Changed_UFSK_FSN_500 XLE_head-side lowering lying
surface_SN2000-4506_230531_en.docx

Safety notice

Restricted use for Treatment chairs 500 XLE with serial numbers 2000-4506

Supplementary application notes to the sections
Maintenance, Spare parts list and Replacement of a component

PROHIBITED - Critical patient positions!

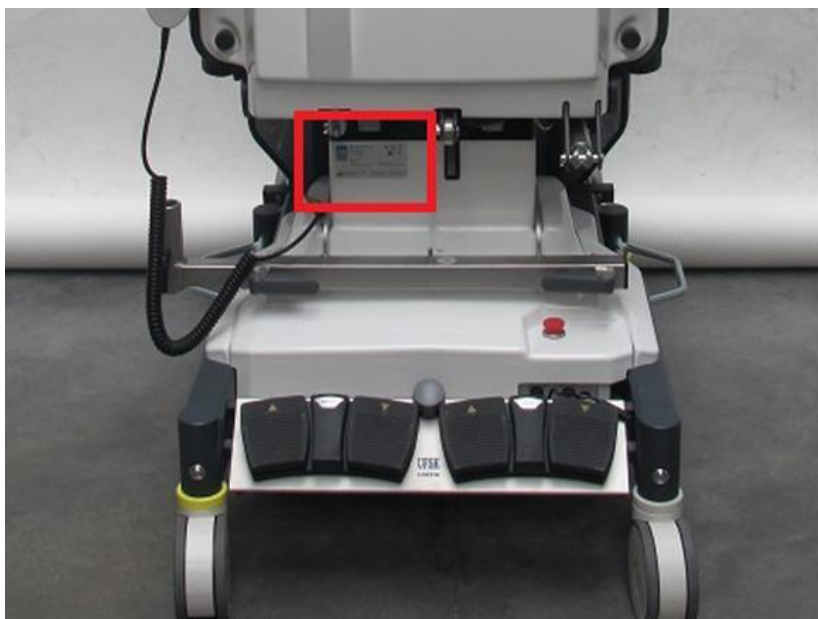
PROHIBITED! Tilting of the seat part by extending the seat part drive is prohibited. Memory positions that have been saved must be adjusted

If the safe patient positions are not observed - in "worst case scenario" - this will cause the separation of the seat drive.

ATTENTION! The seat part must be in a horizontal position to the floor (see green cushion), the seat part drive remains in the retracted position (green marked component). Adjustment movements, e.g. into the reset position, are still possible (see adjustment positions of back and leg part shown in grey).

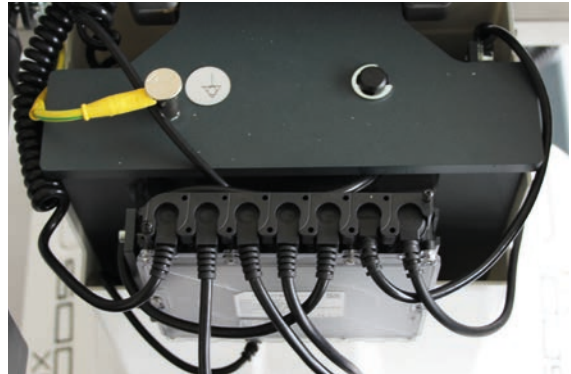
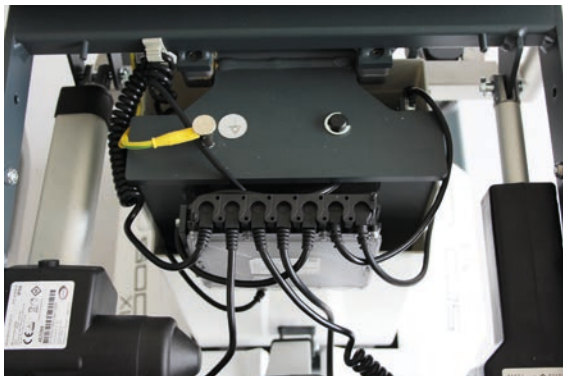
9.b. Remove seat drive, install the new seat drive centrally with both bolts including the two (2) black washers **outside centre** (!) i.e. both washers are to be fitted on the left in front view of the chair (on the right in the direction of the patient's view). Then retract the seatrest completely and slowly move the lifting column downwards.

Attention: Check the adjustment path with regard to collision travel (yellow arrow), if necessary align the left and right chassis cover! Make sure that the lower clip is correctly seated.

Attention:

Lower and upper clip are different

10. Secure both bolts with the clips.
